UNITED STATES PATENT AND TRADEMARK OFFICE

APPLICATION NO.	FILING DATE	FIRST NAMED INVENTOR	ATTORNEY DOCKET NO.	CONFIRMATION NO.
09/273,448	03/22/1999	SHINGO OHKAWA	1185.1044/JD	7146
21171	7590	09/20/2005	EXAMINER	
STAAS & HALSEY LLP SUITE 700 1201 NEW YORK AVENUE, N.W. WASHINGTON, DC 20005			NGO, HUYEN LE	
			ART UNIT	PAPER NUMBER
			2871

Office Action Summary

DETAILED ACTION

Fig. 2

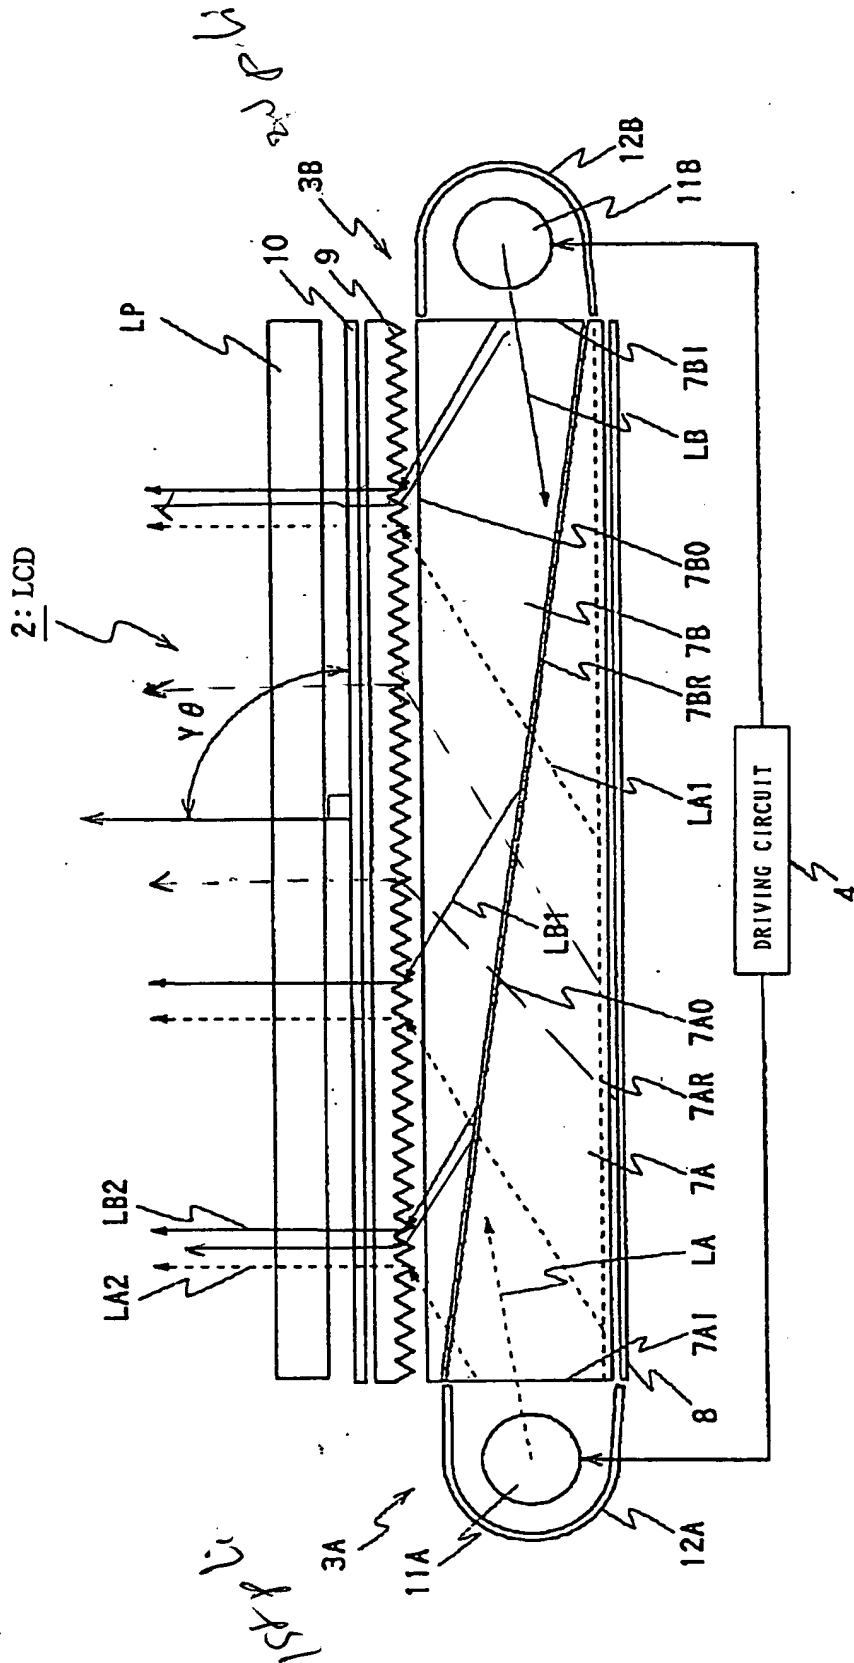
However, in Figure 2 of instant application, The light rays are receivable in all directions; therefore, **there is nothing to avoid** that the first and second slopes BOTH receive light from first primary light source or second primary light source (See attachment for other possible light rays).
